Comment #110: Update to Figure 27

IEEE 802.3 Jan 2020 Interim

Comment #110

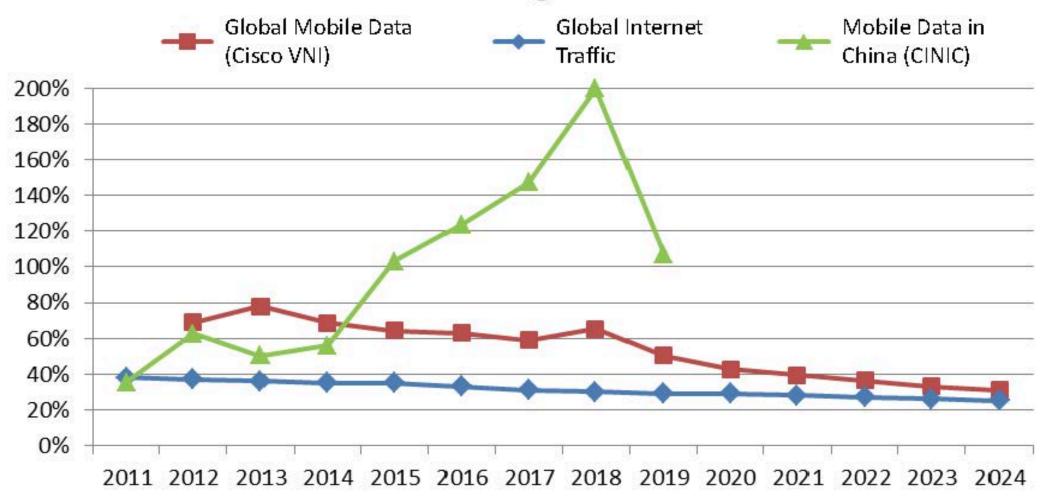
Comment: Vlad Kozlov [LightCounting] has provided updated information for Fig 27. The new data shows a significant decrease in growth rate of China mobile data from 2018 to 2019 - 200% to 100%. This helps to illustrate that significant growth rates will eventually slow down.

- Updated figure provided to editor in email. (See next page).
- Replace last sentence Conversely, the rate of growth for China mobile data has significantly increased from the 2011 to 2018 from 50 % to 200 %. With
- Conversely, as reported by CINIC, the rate of growth for China mobile data significantly increased from 2011 to 2018 from 50 % to 200 %, but fell to 100% for 2019.
